Docket No. LC 82

PACIFICORP, dba PACIFIC POWER,

2023 Clean Energy Plan and Integrated Resource Plan.

Staff Round 0 Comments

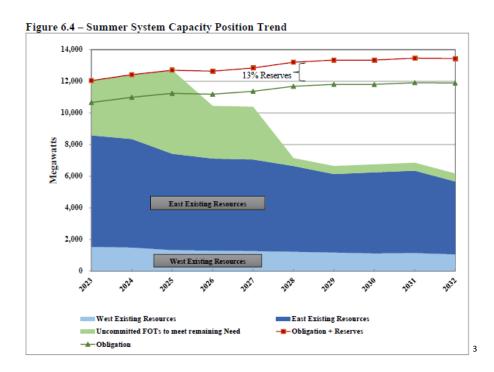
As a system, PacifiCorp expects to be short on capacity and reliant on market purchases in the near term:

In the CEP update staff requests that PAC describe the degree to which this IRP/CEP's proposed energy and capacity actions, along with their proposed allocation under MSP, deviate from the previous IRP.
